SUBJECT: License Amendment Request for Approval of Palisades Nuclear Plant  
10 CFR 50 Appendix G Equivalent Margins Analysis

Palisades Nuclear Plant  
Docket No. 50-255  
License No. DPR-20

### Responses to Request for Additional Information Questions

WCAP-17651-NP, Revision 0, Updated Figure 5-2 with Corrected, Limiting, Level C and D Transients

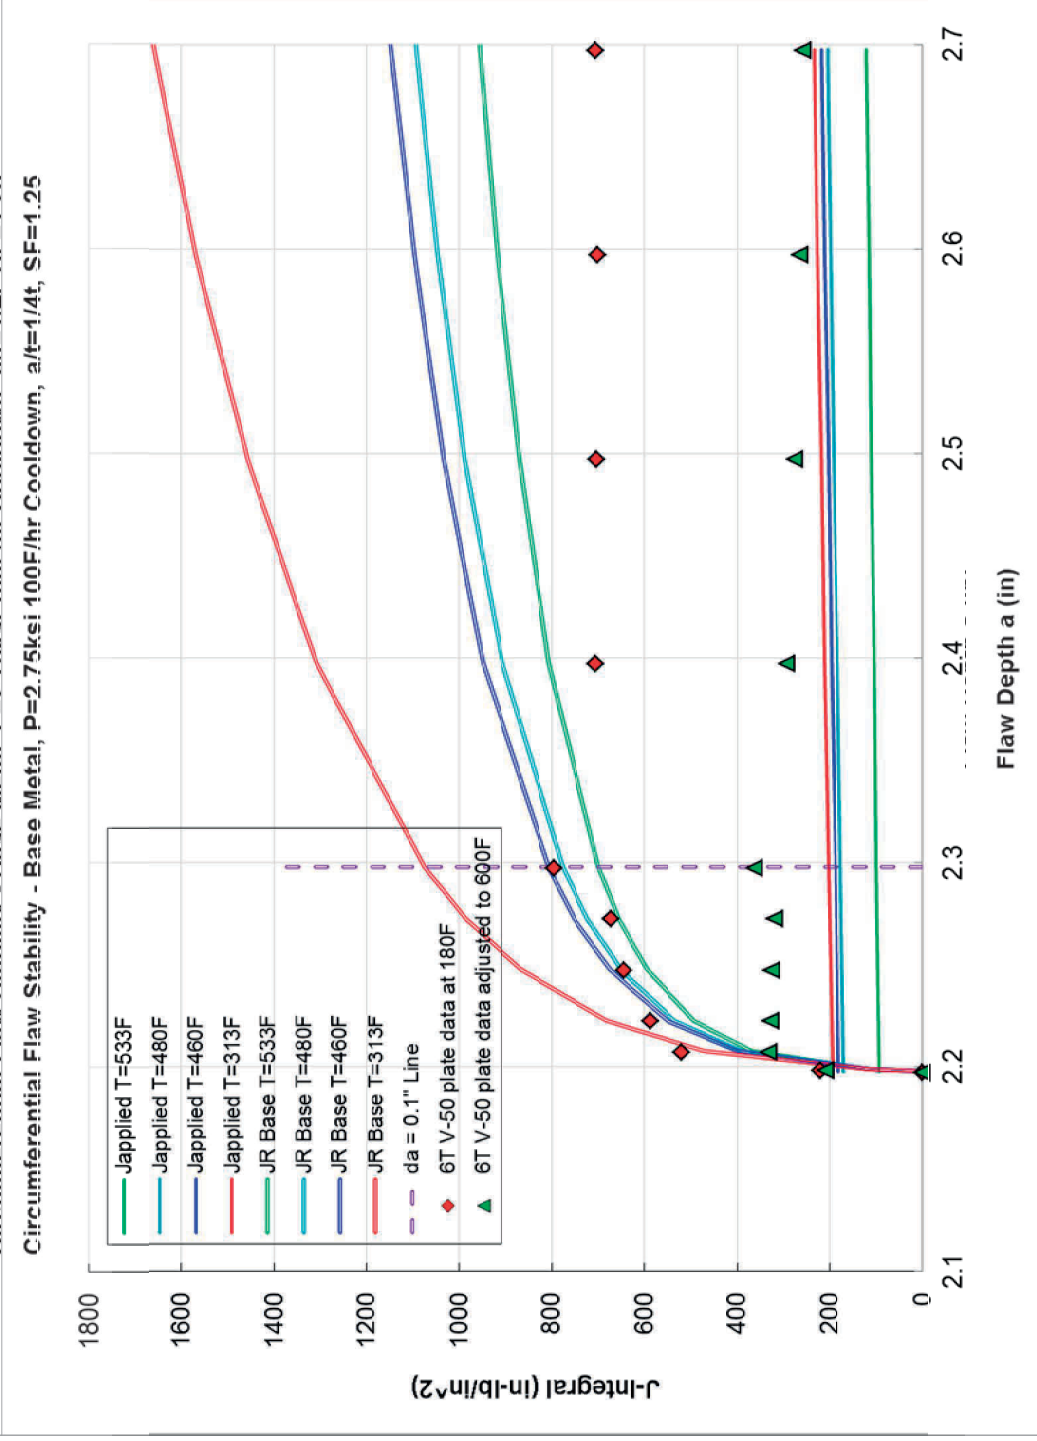
Westinghouse discovered during the development of this RAI response that the Level C and D loading J-applied curves plotted in WCAP-17651-NP, Figure 5-12, were not the most limiting case. This error also propagated onto Figures 5-2 and 5-13 in the WCAP. This has been updated in the attached figures as part of this RAI response. Note that the conclusions to the report, including the safety factor determination, are unchanged; only

the figures were in error. This has been documented in the Westinghouse corrective action system, and will be corrected when the WCAP is revised to incorporate these RAI changes.

WCAP-17651-NP, Revision 0, Updated Figure 5-9 with V-50 Plate Data Included

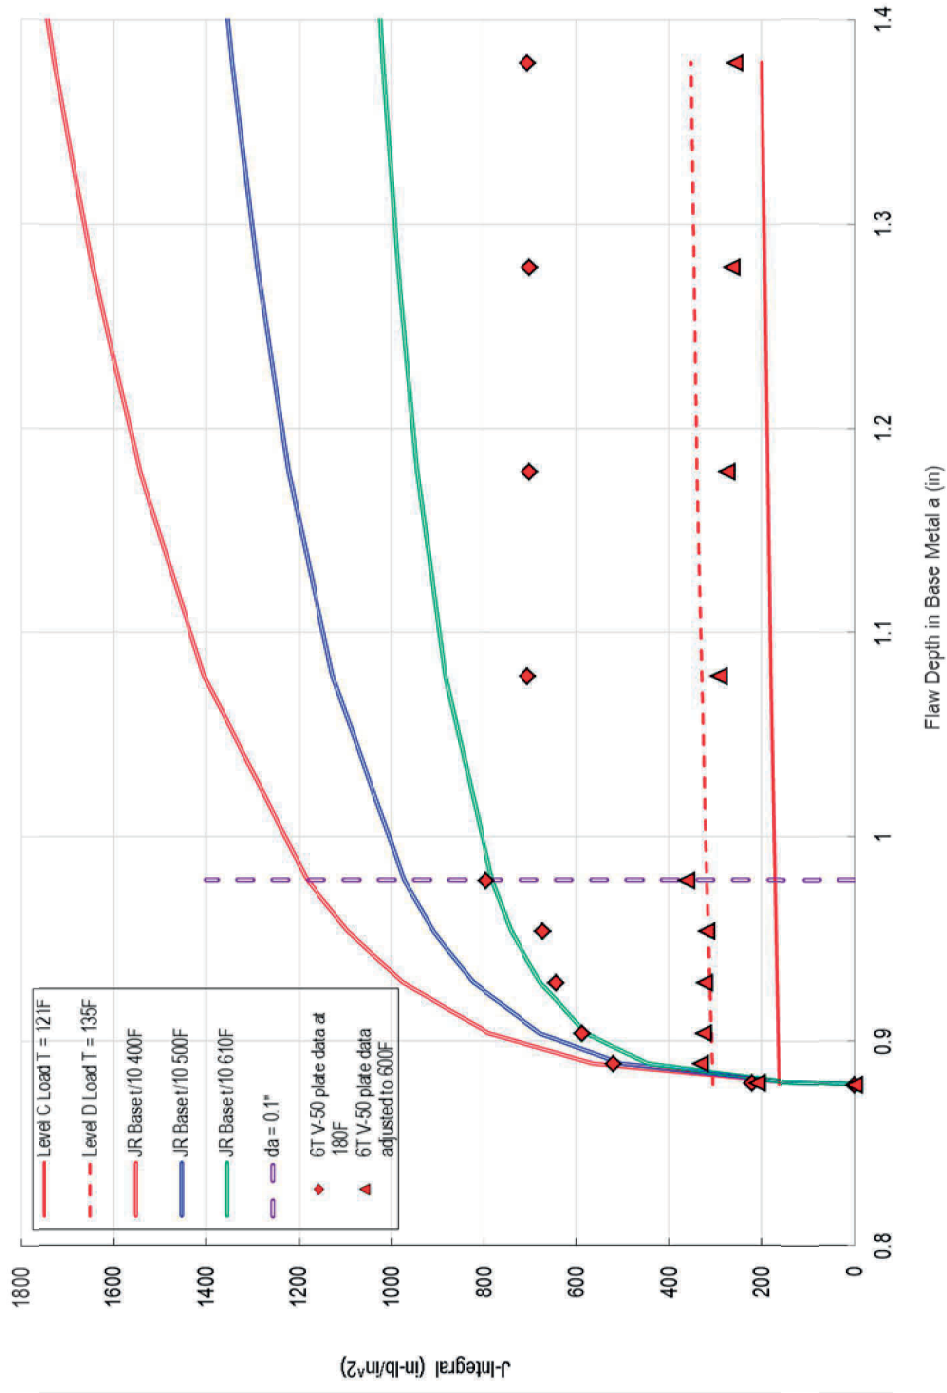
6. Section 6 presents conclusions of this submittal. For Service Level C condition with 400°F/hr cooldown, it is concluded that, "The equivalent margins analyses for the plate materials are acceptable and bounded by the conservative test data reported in NUREG/CR-5265 in all cases for the Level C transient." This conclusion was repeated later for Service Level D condition with 600°F/hr cooldown, with "C" in the quote replaced by "D." Plot the relevant NUREG/CR 5265 6T data in Figure 5-12 and provide sufficient justification to support your conclusions.

Updated Figures 5-9 and 5-12 with the V-50 plate data are provided below, along with added Tables 5-4 and 5-5 showing the Level C and D safety factors, respectively. Table 5-6 was added, which demonstrates the available margins on pressure loading with the V-50 plate data, adjusted for temperature, with consideration of all service loadings, Level A, B, C and D. The minimum safety factor (SF) with consideration of the V-50 plate data and the PNP-specific J-applied values is 1.5, which is above the minimum required SF of 1.15 per RG 1.161.

Figure 5-8 from WCAP-17651-NP, Revision 0, along with the updated Figures 5-9 and 5-12 below, all demonstrate that at  $J_{\text{applied}} = J_{\text{material}}$ ,  $dJ_{\text{applied}}/da < dJ_{\text{material}}/da$ , is satisfied for all three cases (i.e., the slope of the  $J_{\text{applied}}$  is smaller than the  $J_{\text{material}}$  at the point of intersection).
